Product Change Notification

Date Issued :	August 22, 2025	PCN Number :	517237
Reason for Change :	Change to Product		
Description of Change :	This changes to informed about the changes Dimension in Sales Drawing.		
Reason for Short Notice :	Corrective Actions		
Assessment of Change :	No change to parts - Form/Fit/Function		
Planned Implementation Date :	October 15, 2025		
Customer Sample Availability Date:	September 05, 2025		
Last date to request Samples by Customer :	September 05, 2025		
Please note if Samples are not requested as per Customer Samples Request date, it may take additional 4-6 weeks to arrange Samples.			
Traceability Code Markings / Date :	No special marking on the product or packaging

Before Picture

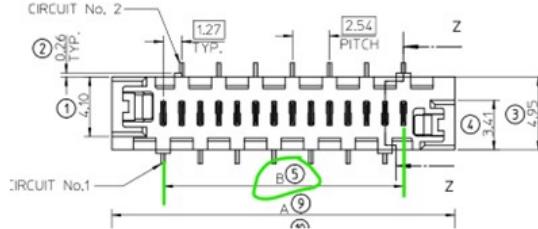
- As per the PSD initially, the dimension B was measured from the first circuit to the last second circuit which is not correct. After revision, the dimension B is measured from the first circuit to the last circuit.

- 90816- Dimension B should be measured from the first circuit to the last circuit. But as shown in the above figure, there is a discrepancy observed where it is measured from the first circuit to the second last circuit.
- After revision, the dimension B will be measured from the first circuit to the last circuit as shown in the figure above.
- Part Number Impact
 - 90816 series
- Product Impact
 - No impact to form, fit & function.
- PCN will be implemented once all required qualification/ validation has been completed, and all necessary approvals have been obtained
